DESIGN REVIEW BOARD WORK SESSION

Design Review Board Case # 2020-00003
Block P – 765 John Carlyle – South Tower

Block P – DRB Work Session

Above: Staff's sketch as related to item A-1. above.

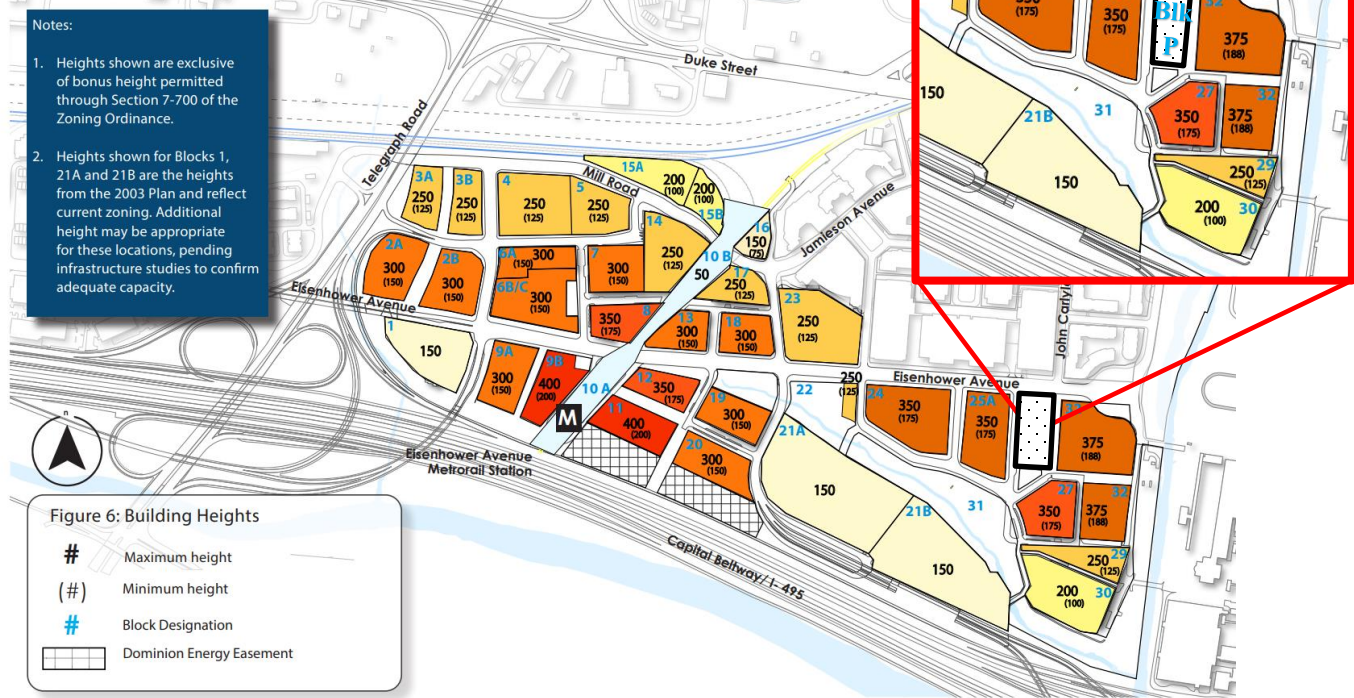
1. Consider lowering the height of the connector piece to emphasize the verticality of the towers. (see sketch below)
2. Additionally, consider aligning the face of the penthouse (along *future* John Carlyle Street) with the bulk of general massing of the building for said reasons. (also see sketch below)

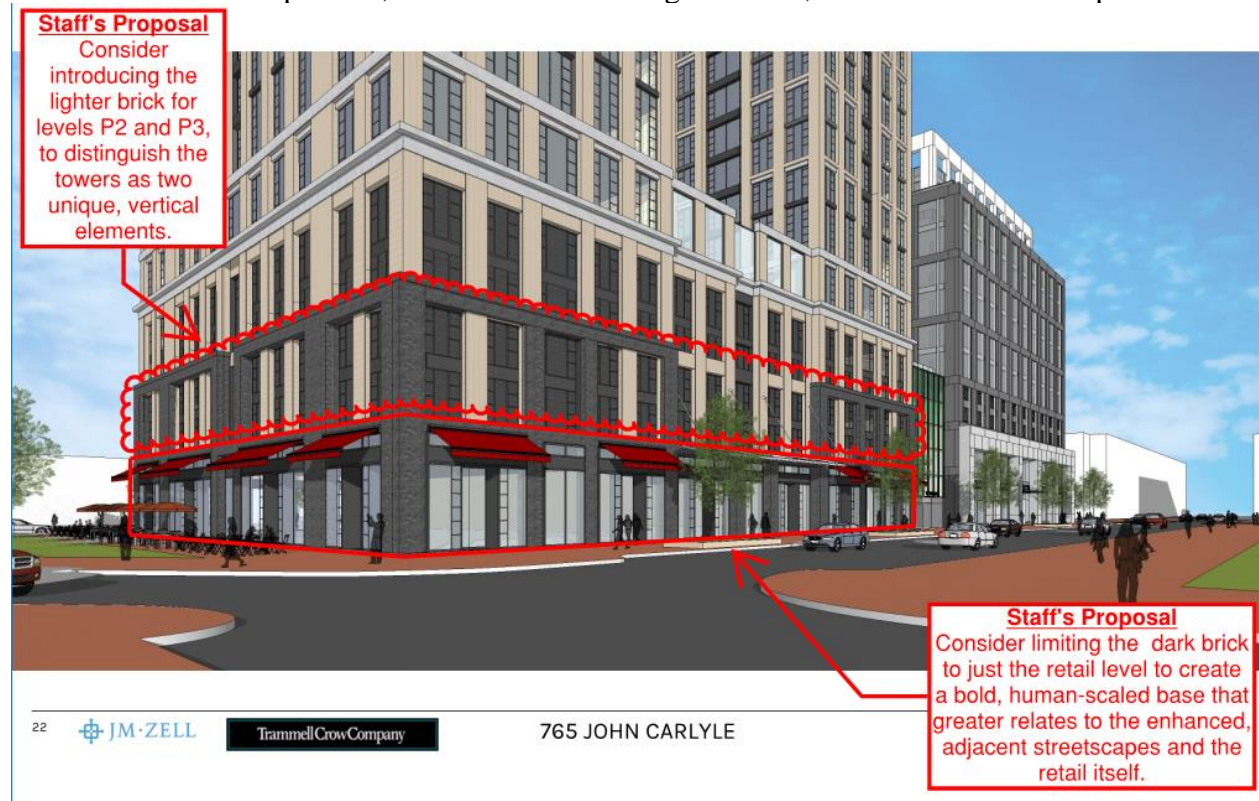
With this iteration, the applicant has reverted to the previously approved garage level screening- in which is a system of spherically-perforated metal panels arranged to mimic typical windows are utilized. However, the graphics themselves, as described more thoroughly in section E – Graphics, contain inconsistencies which shall be reconciled prior to final approval.

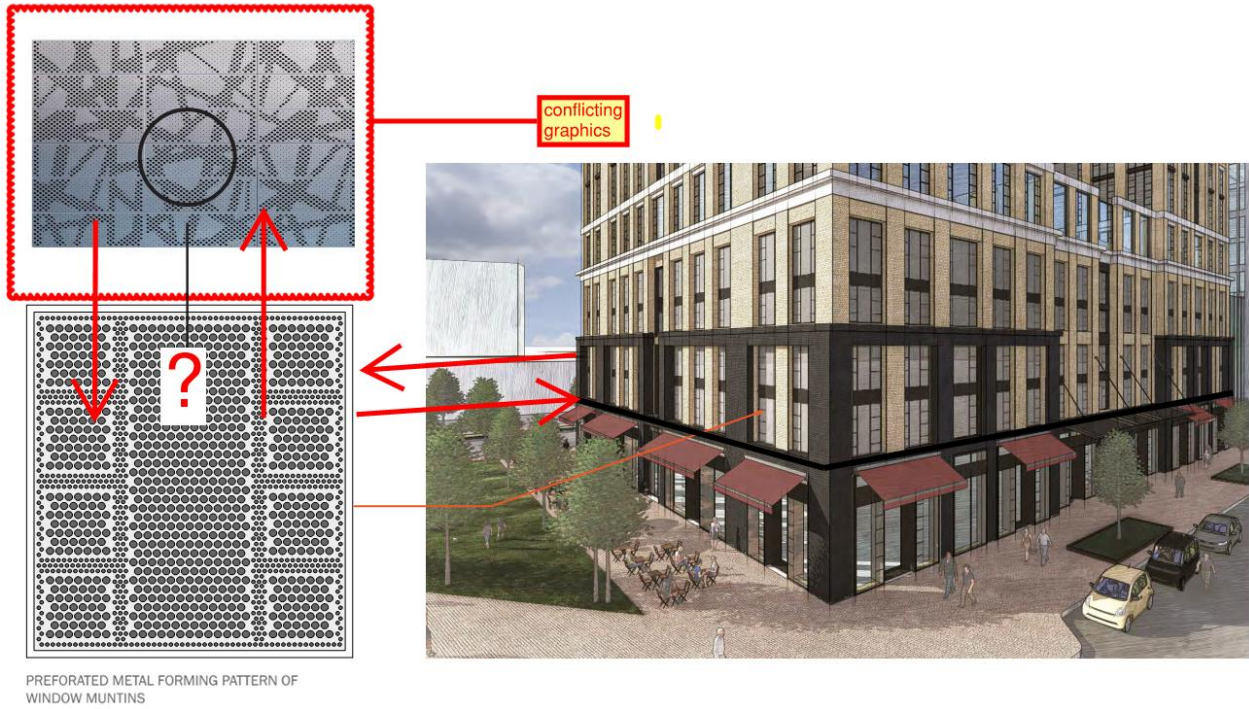
As previously noted, the dark brick materiality – apparently superimposed on the south tower base to relate to the lower base datum line on the north tower – detract from the strong base of the southern building. A more successful application would be to use the materiality to express only the retail level of the podium, and to revert to the lighter brick, as noted in the markup below.

Additionally, the change in the awning’s materiality from an industrial expression to an apparent “wind-up” variant is concerning from a design, safety and operational perspective. Therefore, the Applicant shall revert to the original, steel and glass awning, which better relates to the modern, refined architecture of the block.

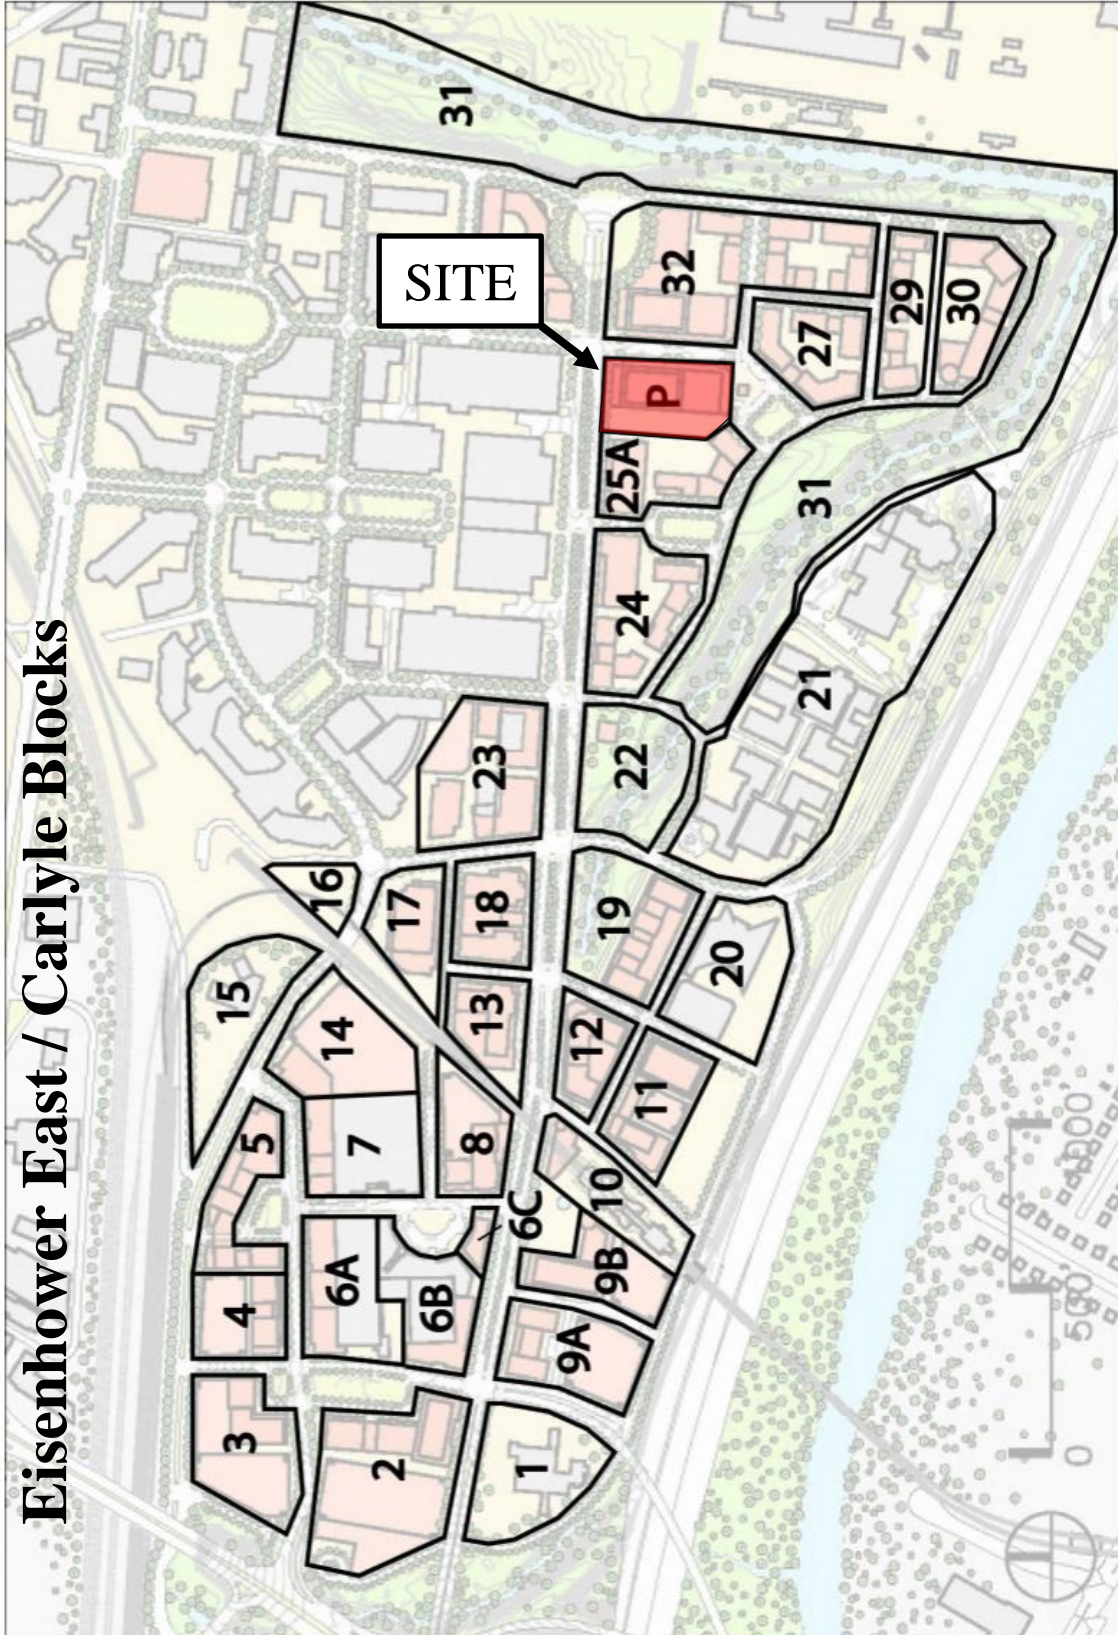
The graphics with this submission are a general improvement. However, those which depict the perforated metal screening used to conceal the above-grade garage levels (P2 – P5, see below) are inconsistent and must be reconciled.

There are also inconsistencies with the labeling of the materiality, as illustrated in a markup below. therefore, all elevations shall be reconciled to include the correct material call out.
